# 2022/4099/P &2022/4735/L 11

Delegated Report	Analysis shee	et	Expiry Date:	27/12/2022	
	N/A		Consultation Expiry Date:	11/12/2022	
Officer		Application N	umber(s)		
Obote Hope	(i) 2022/4099/P (ii) 2022/4735/L				
Application Address	Drawing Numbers				
11 Chamberlain Street London NW1 8XB		Refer to draft d	ecision notice		
PO 3/4 Area Team Signat	ture C&UD	Authorised Of	ficer Signature

- (i) Demolition of existing lower ground floor extension and reconfiguration rear garden terrace and basement, installation of PV panels on the main roof, rebuilding of the mansard roof extension and alteration to the fenestration/façade treatment to the front and rear.
- (ii) Demolition of existing lower ground floor extension and reconfiguration rear garden terrace and basement, recladding of modern roof extension, rebuilding of the mansard roof extension and installation of PV panels on the main roof, alterations to the fenestration/façade treatment to the front and rear, with associated internal reconfiguration including the installation of new internal staircase arrangement.

Image 6. Existing and proposed front and rear elevations.

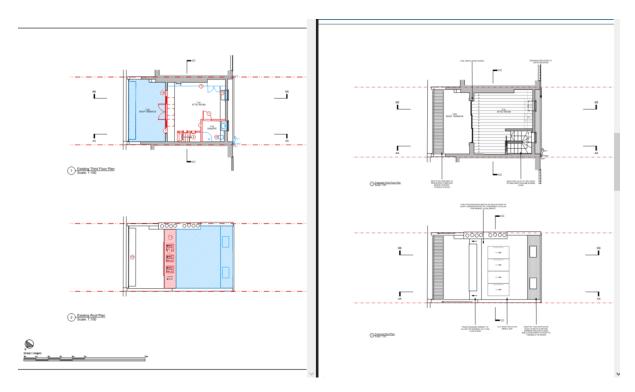
The proposal seeks to re-clad and tidy up the roof, while refining the massing.

With sliding doors split into three, the fenestration is aligned with the rhythm and axis of the facade below. To either side of the opening, the roof form is reinstated back to the original pitch to assist in expressing a more traditional dormer arrangement .

The railing will follow the form of the existing but will instead be replaced with delicate and slim vertical bars - which will read more subtly and in keeping with the context
